Project Name: UNIVERSITY OF CALIFORNIA, MERCED

KOLLIGIAN LIBRARY 3W RENOVATION

ADDENDUM NO. 1

July 20, 2018

G001

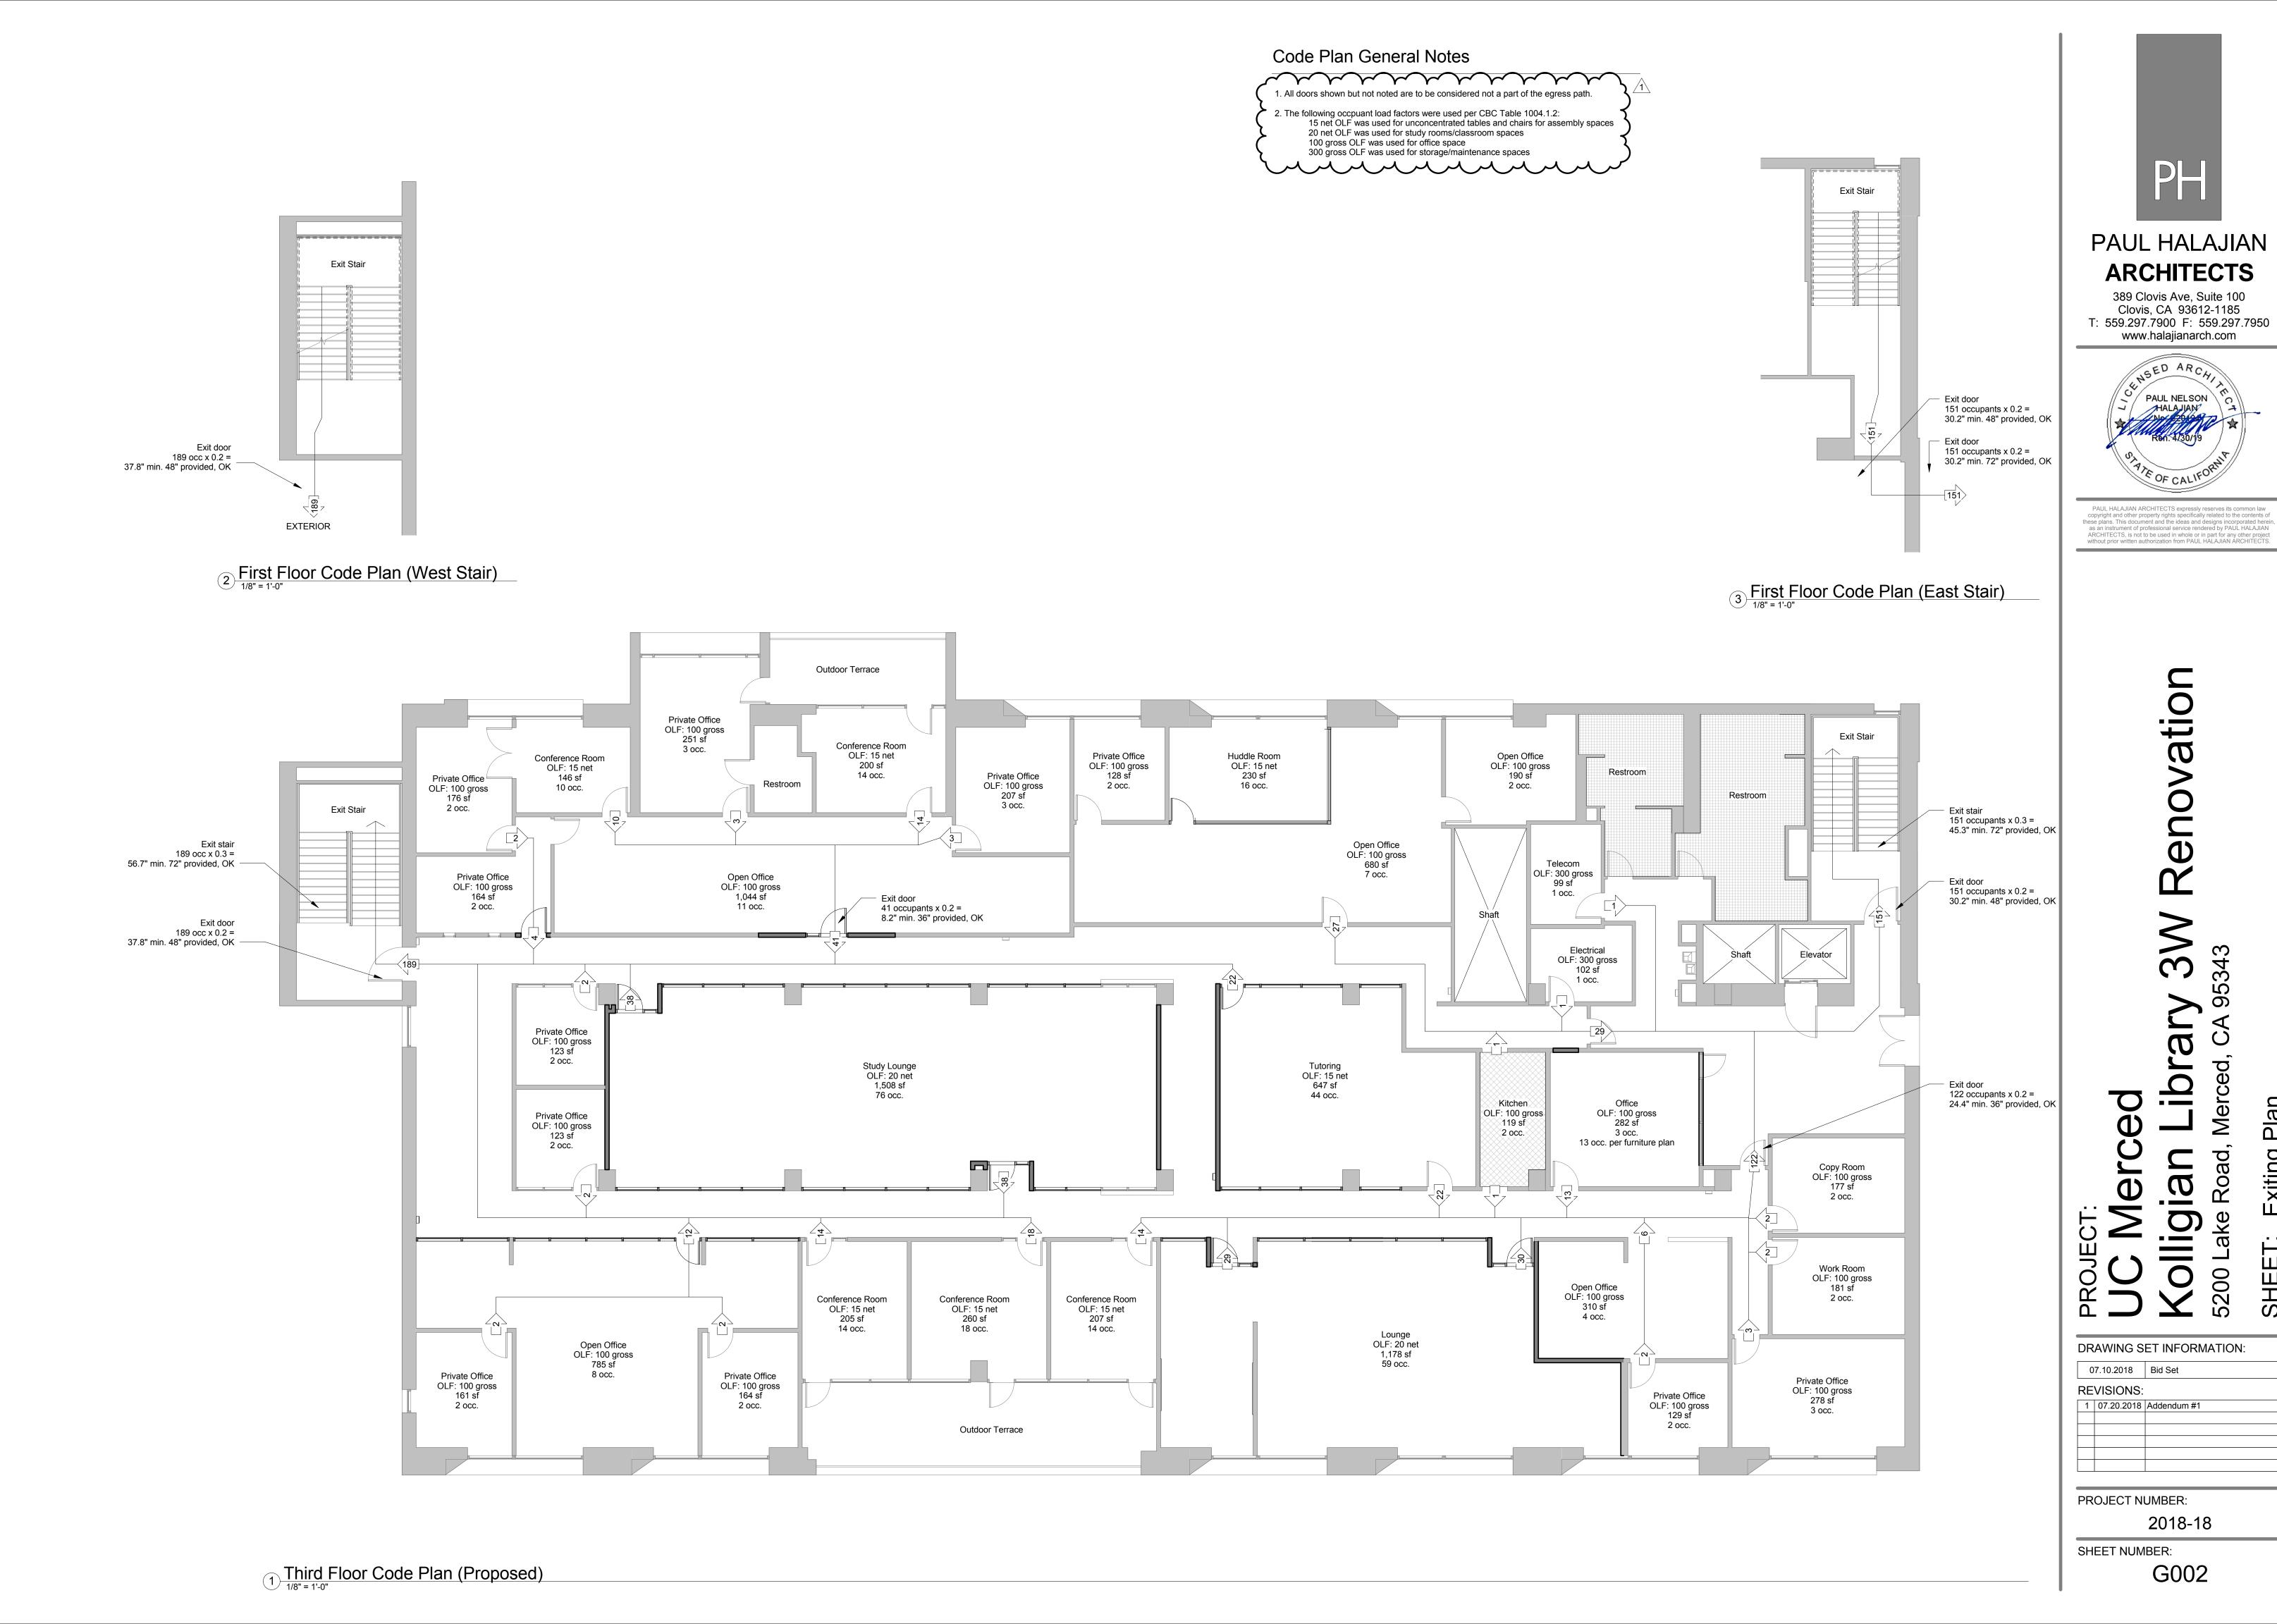
- 2. Item 01-02
 - a. Reference: G001
 - b. General Note #8 Verify signage exists. If it doesn't exist or is not compliant, provide per details.
 - c. General Note #12 Specification reference added to general note. No change in scope, clarification only.

SHEET NUMBER: A202

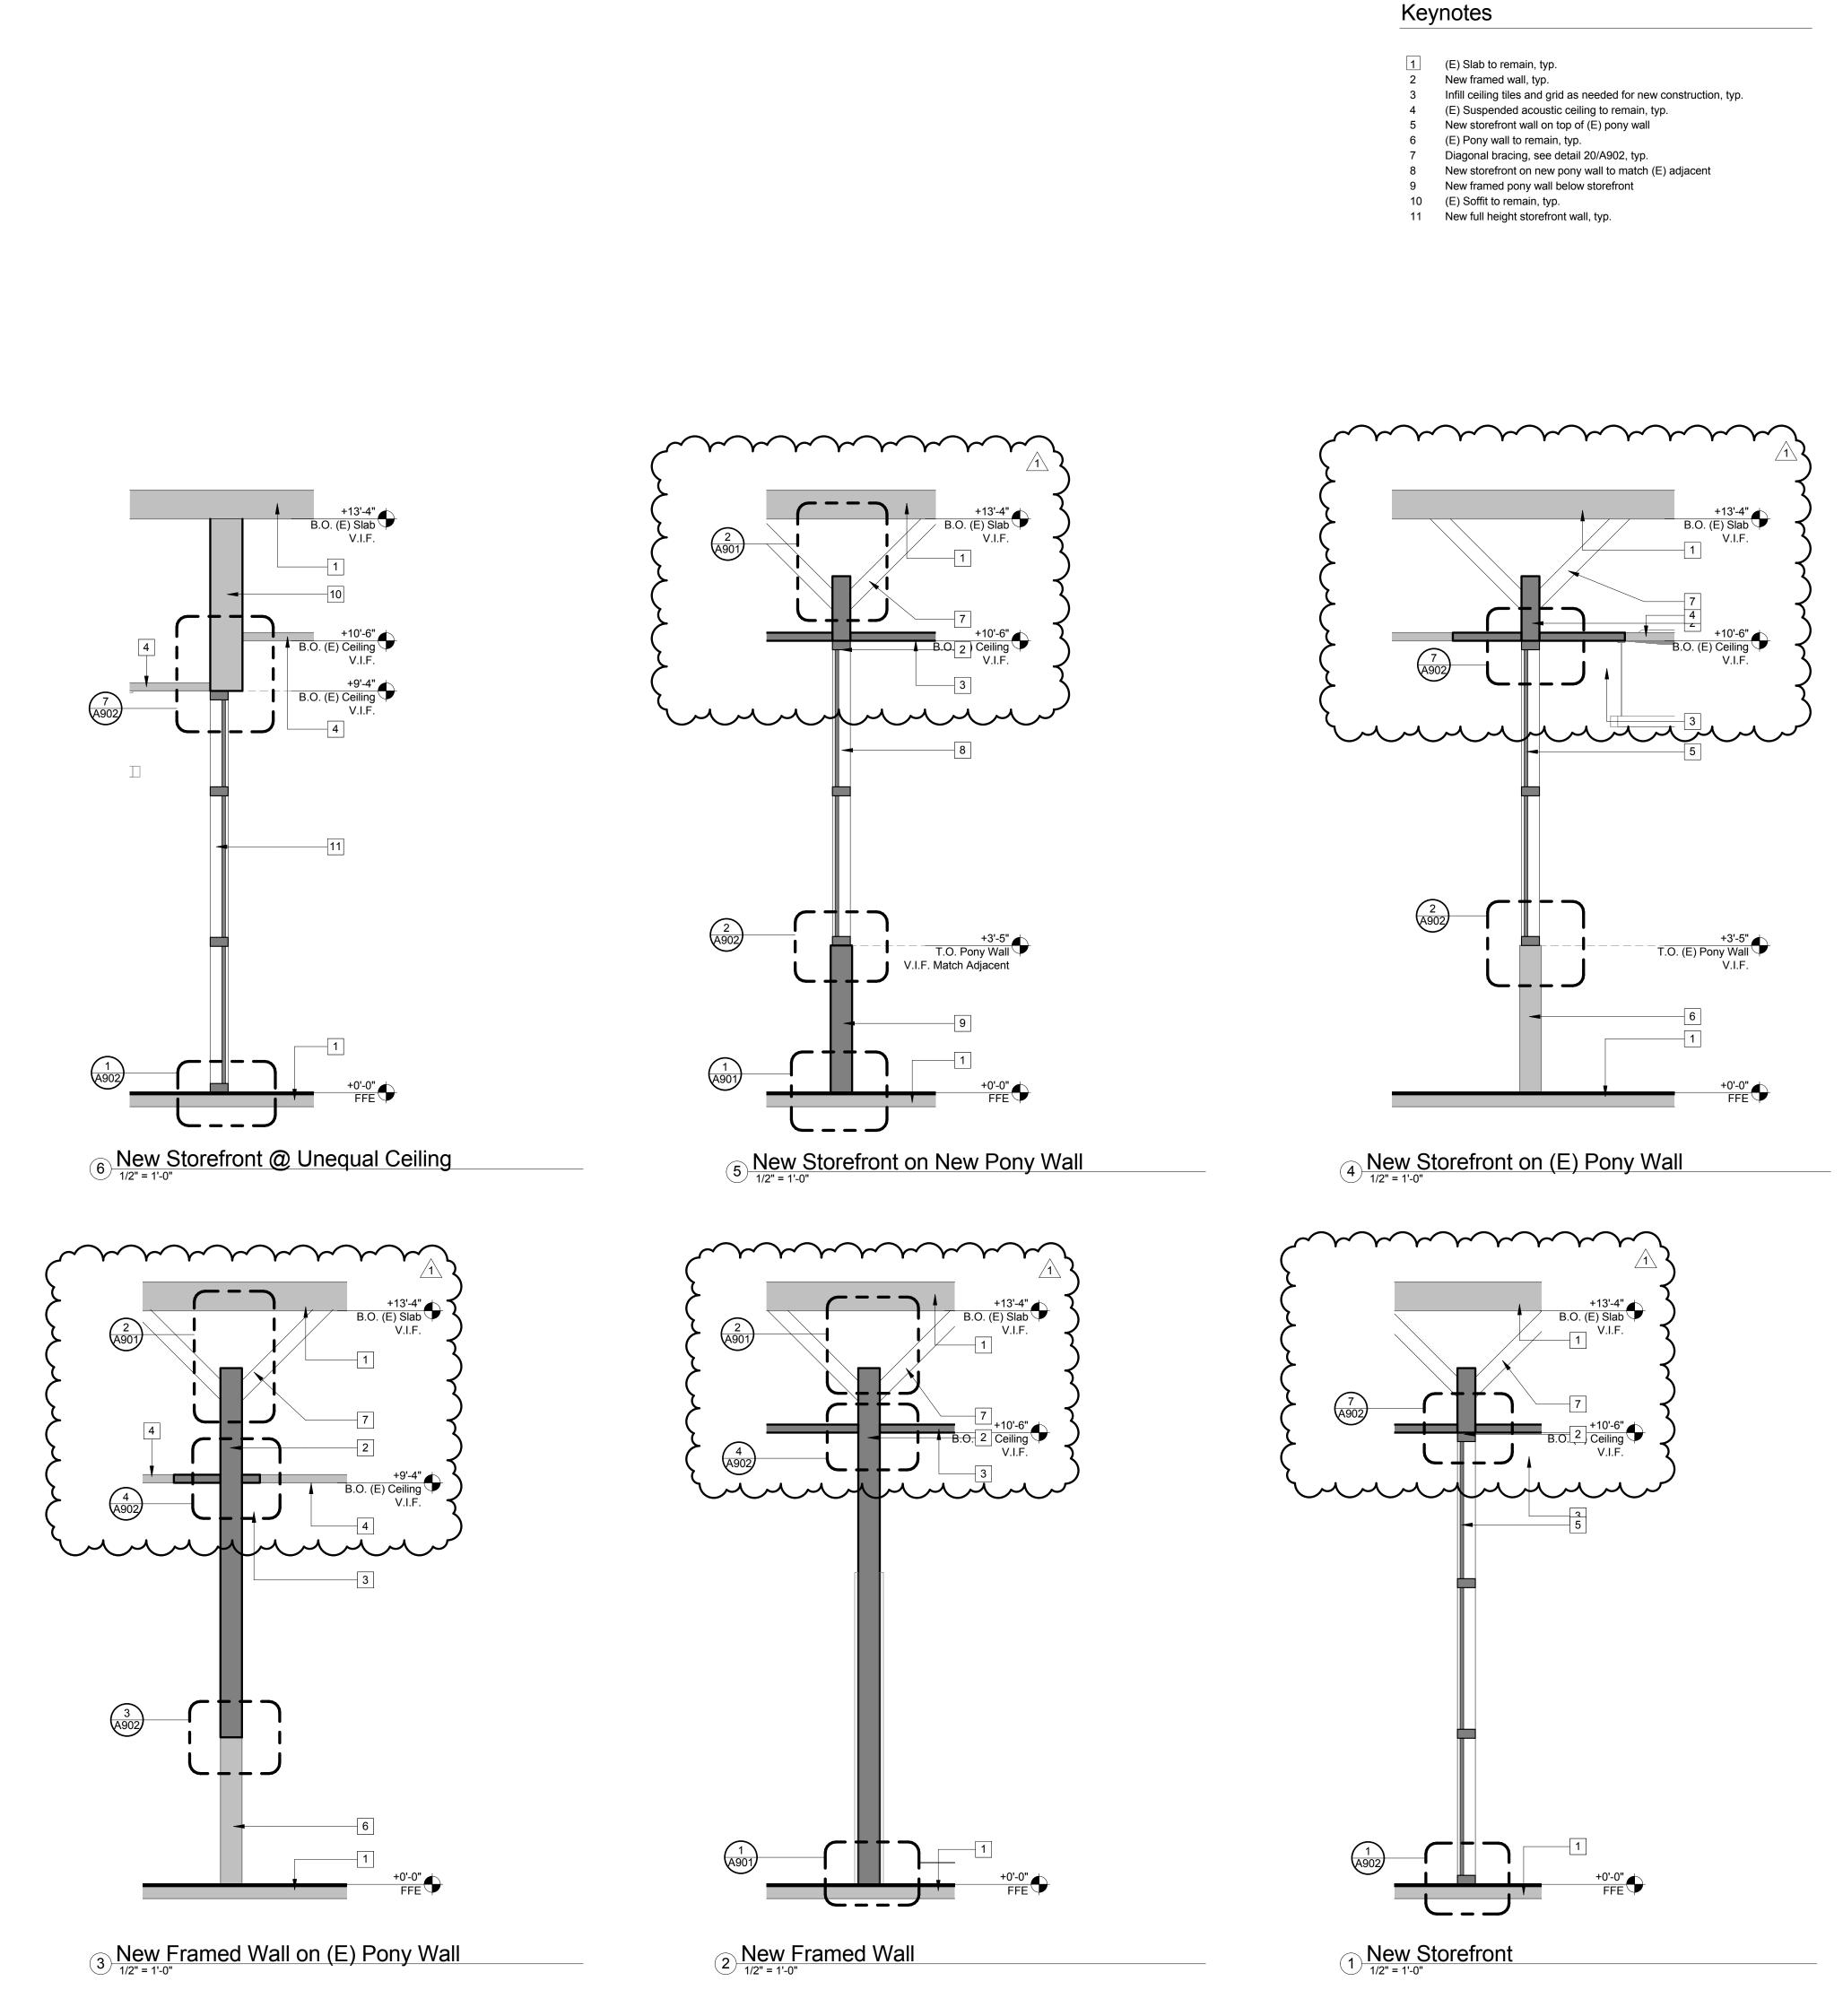
- a. Reference: A202
- b. Note added to sheet to reference power and data hookups per forthcoming Electrical. No change in scope, clarification only.
- 7. Item 01-07
